**Town of Davidson  
Design Review Board Regular Meeting  
Town Hall and Community Center  
Community Room 120  
251 South Street  
Wednesday, November 19, 2025 at 5:30 PM**

## DESIGN REVIEW BOARD: PRELIMINARY STAFF REPORT

Date: November 19, 2025  
To: Design Review Board  
From: Lindsay Laird, Senior Planner  
Re: Summit Farms Roastery & Gastro Pub Buildings – Informal Review #1

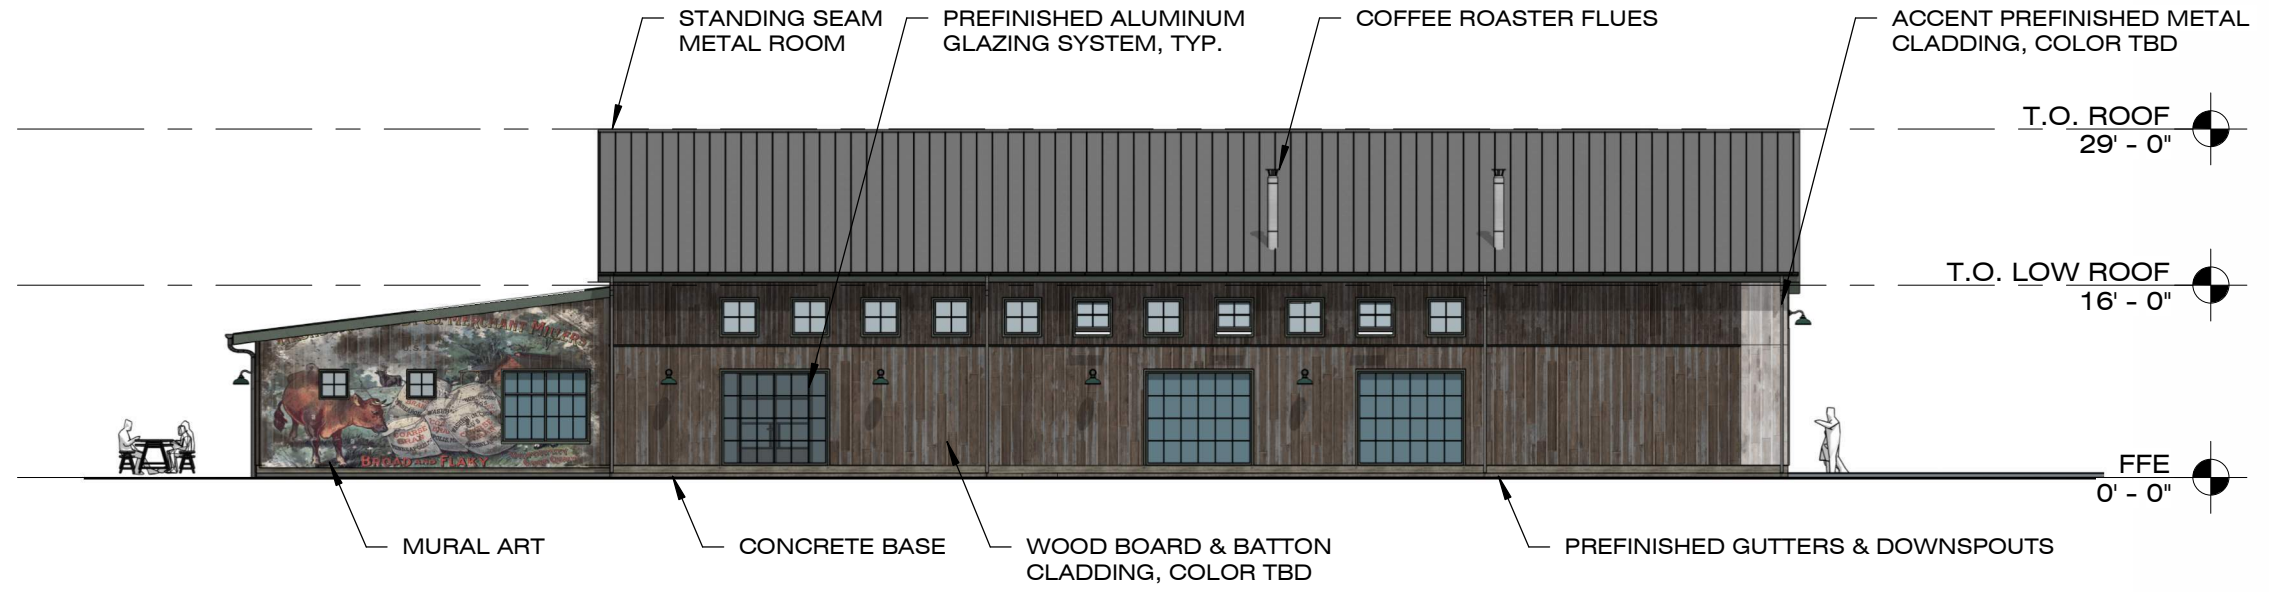
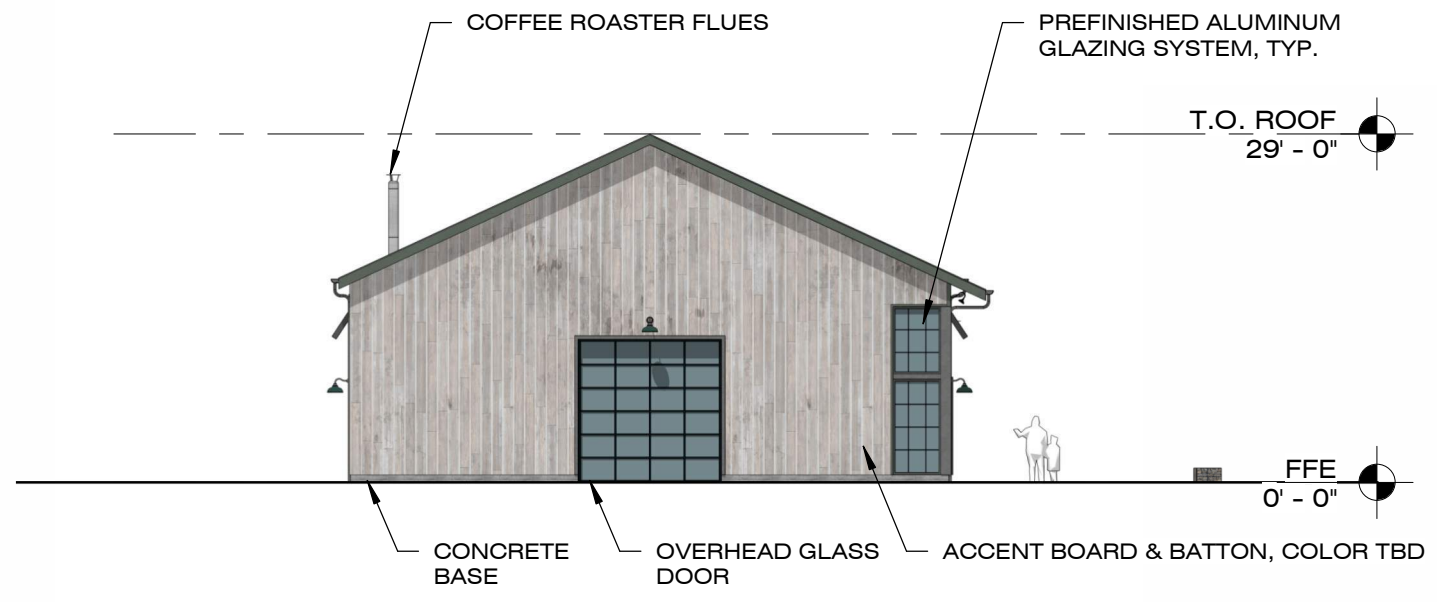
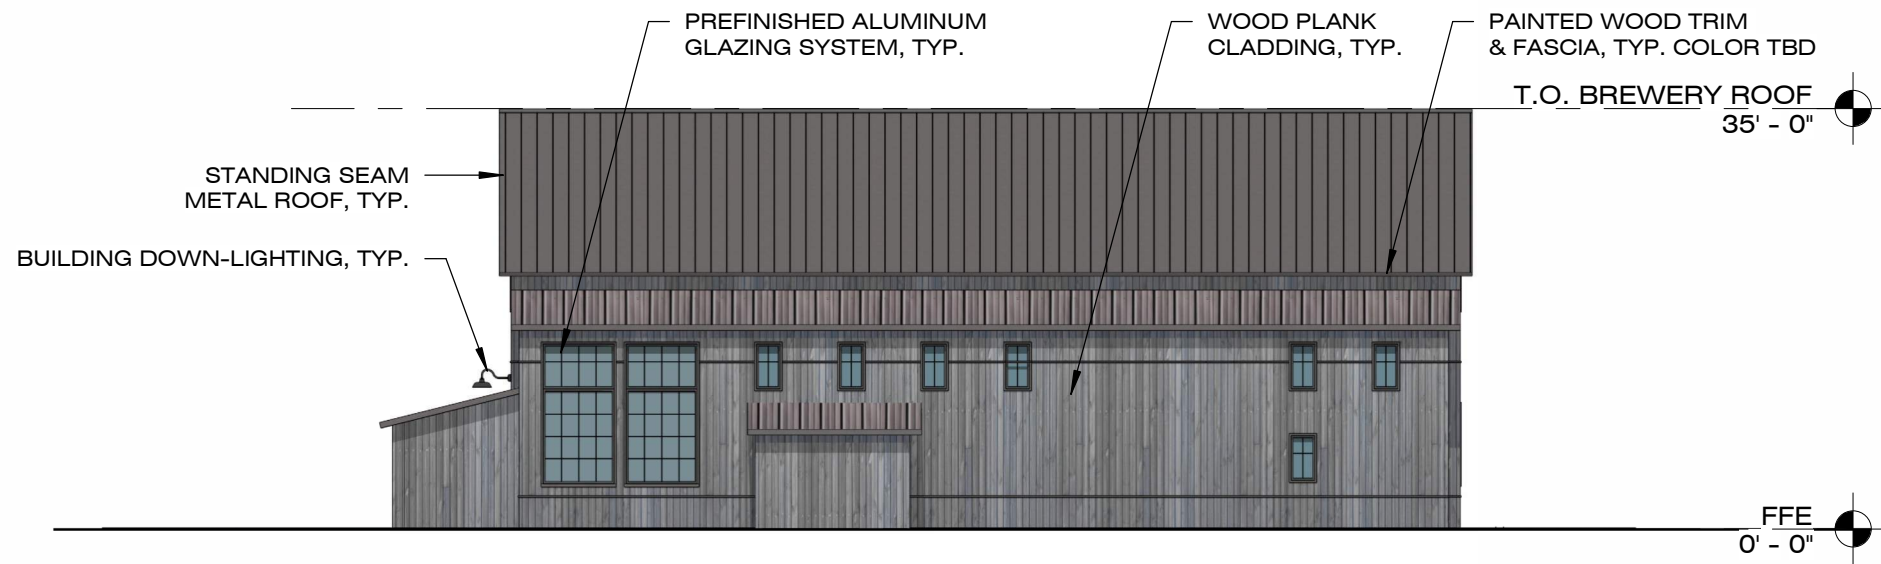
*A transparency calculation was not provided by the applicant. First-floors of both buildings do not appear to meet the 50% minimum transparency requirements on Shearer Road facades. This will require a design condition if the DRB supports this approach. The Board should provide feedback on the proposed glazing percentages based on rural vernacular.*
